**Committee of Experts on the Transport of Dangerous Goods  
and on the Globally Harmonized System of Classification  
and Labelling of Chemicals**

**Issues relating to the Globally Harmonized System  
of Classification and Labelling of Chemicals:  
corrosivity criteria**

**Proposal for revision of Chapter 2.8 of the Model Regulations  
(Amendments to the proposal in ST/SG/AC.10/C.3/2014/69 –  
ST/SG/AC.10/C.4/2014/12)**

**Transmitted by the European Chemical Industry Council (CEFIC)**

**Figure 2.8.23: Flow chart scheme for assignment of packing group for mixtures with hazard classification 8A based on additivity calculations**

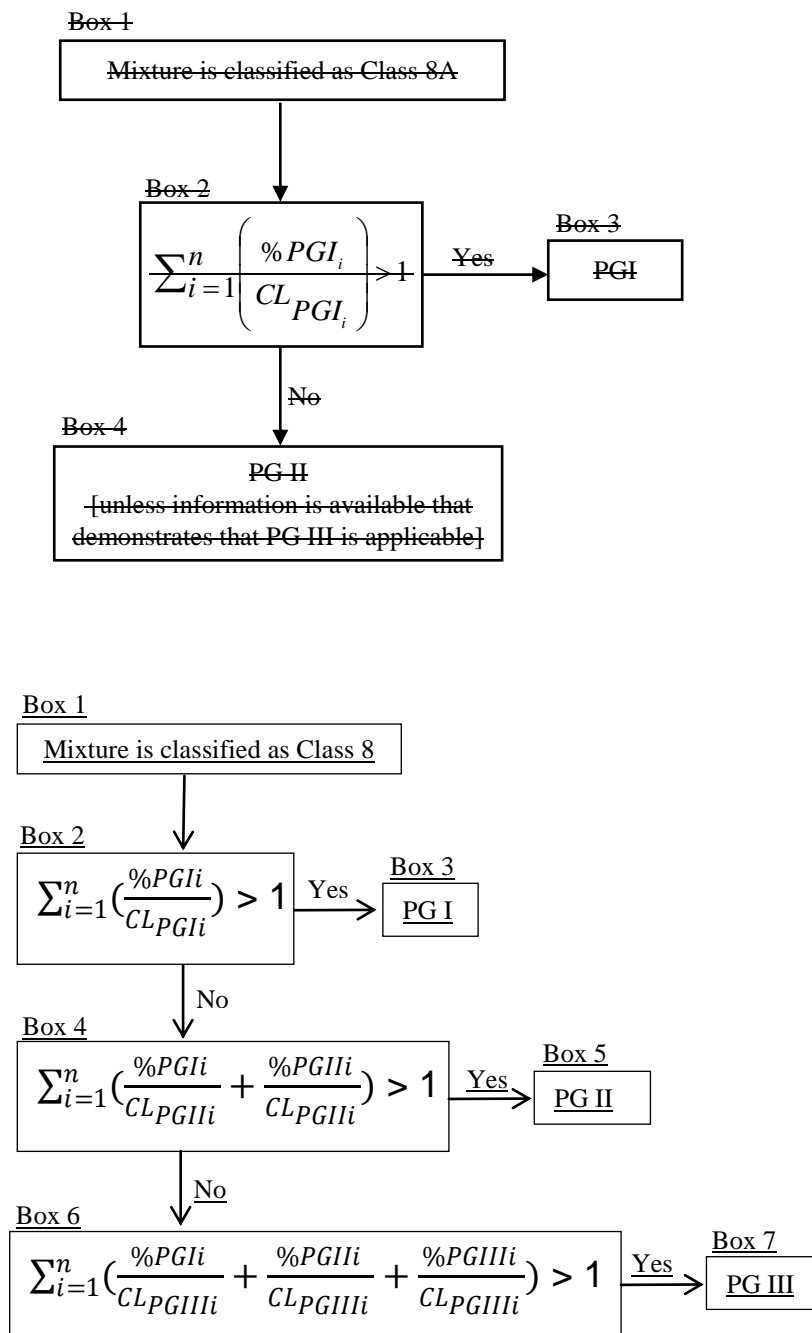
11. As a consequence when omitting the implementation of sub-classification, the starting point for the additivity approach turns out to be the evaluation of the packing groups of the components of the mixture. The description in Figure 2.8.3 has been amended accordingly in analogy to the non-additivity approach described in Figure 2.8.4 of the revised proposal.

2.8.3.4.5 Notwithstanding 2.8.3.3, the packing group of mixtures classified as Class 8A based on additivity calculations (see 2.8.2.3.2.2.3.2 and 2.8.2.3.2.2.3.3) may be assigned using the following method:

**Notes to Figure 2.8.23:**

*CL<sub>PG I</sub> is the concentration limit for ingredient i with packing group I. This concentration limit can be either a specific concentration limit from the Dangerous Goods List or generic concentration limit from Table 2.8.3.4*

**Figure 2.8.34: Flow chart scheme for assignment of packing group for mixtures classified as Class 8 without sub-classification based on non-additivity**

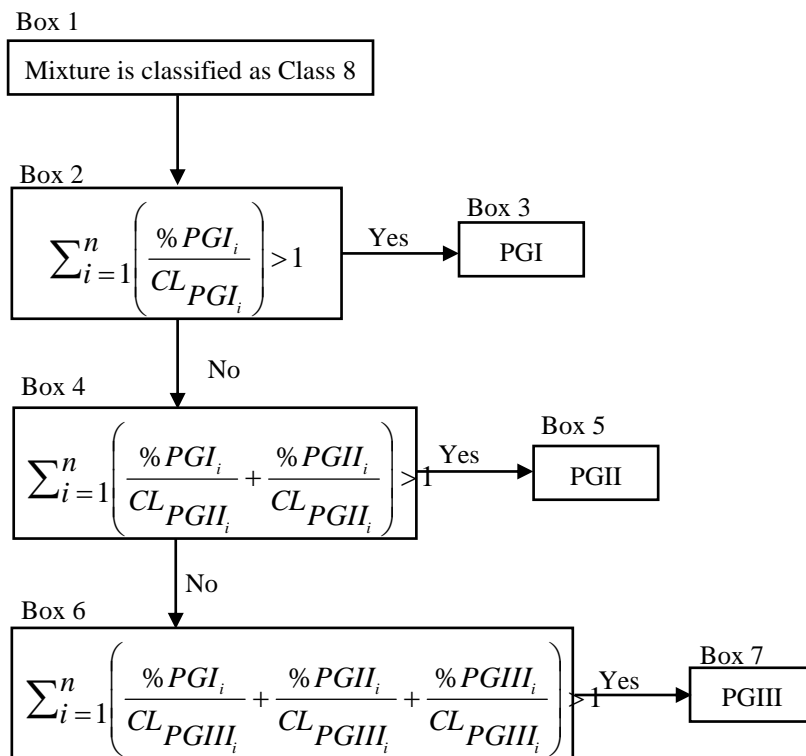
2.8.3.56 Notwithstanding 2.8.3.3, the packing group of mixtures classified as Class 8 ~~without sub-classification following the non additivity approach or using the extreme pH-value may~~ be assigned using the following method:

**Notes to Figure 2.8.34:**

*CL<sub>PG I<sub>i</sub></sub> is the concentration limit for ingredient i in PG I. This concentration limit can be either a specific concentration limit taken from the Dangerous Goods List or the generic concentration limit from Table 2.8.4.5*
